CHANGES FROM SCHEME PERMITTED UNDER ABP-307415-20:

North Elevations Permitted & Proposed

Project		6-7 HARDCOURT TERRACE, DUBLIN 2, IRELAND	
RESIDENTIAL APARTMENTS, LISIEUX PARK		1 + 363-1-618 2100 1 + 363-1-676 7385	
Murphystown Road, Leopardstown, Dublin 18		www.bkd.ie	
Drawing Title		North Elevations - Permitted and Proposed	
Stage	Scale	Drawn	Date
Planning	1:200@A1	SR	23.05.2022
Project Code	job	origin	zone
6275	LIS	BKD	ZZ
level	type	dis	sheet no.
	DR	A	2000
status	rev		
P01

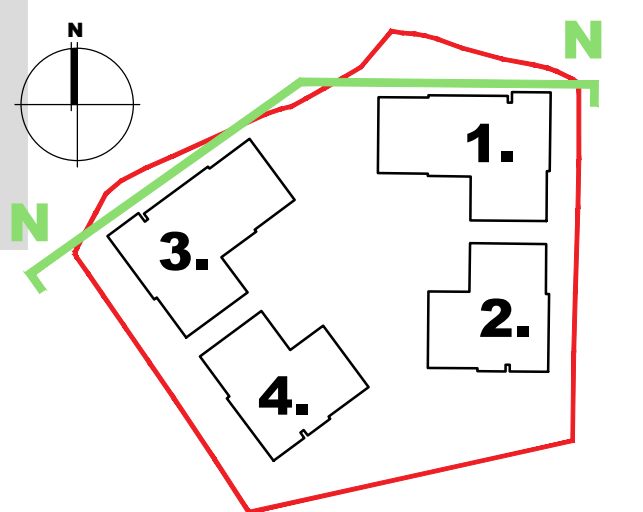
- (1) ALL PERMITTED BEDROOM DOORS
OPENING ON TO BALCONIES CHANGED
TO WINDOWS TO IMPROVE SAFETY
AND SECURITY.
- (2) PERMITTED GLAZED ATRIUM AT ROOF
LEVEL (ABOVE STAIR AND LIFT CORE)
REMOVED FOR FSC PURPOSES
- (3) GLAZED LINK CORRIDORS BETWEEN
BUILDINGS REMOVED
- (4) FENESTRATION SHOWN IN ELEVATION
TO TALLY WITH PERMITTED PLANS
- (5) MINOR CHANGES TO FENESTRATION
TO ACCOMMODATE IMPROVED
APARTMENT FLOOR PLANS
- (6) WINDOWS TO WC SHOWER AREA
OMITTED FOR PRIVACY
- (7) MODIFICATIONS TO FACADE TO
ACCOMMODATE REQUIRED VEHICLE
HEIGHT AT ENTRANCE TO BASEMENT
CAR PARK, FOR PART M & DAC
COMPLIANCE PURPOSES
- (8) REVISED ENTRANCE TO CRECHE
- (9) NON-STRUCTURAL COLUMNS OMITTED
FROM BALCONIES TO IMPROVE
DAYLIGHT INTO APARTMENTS
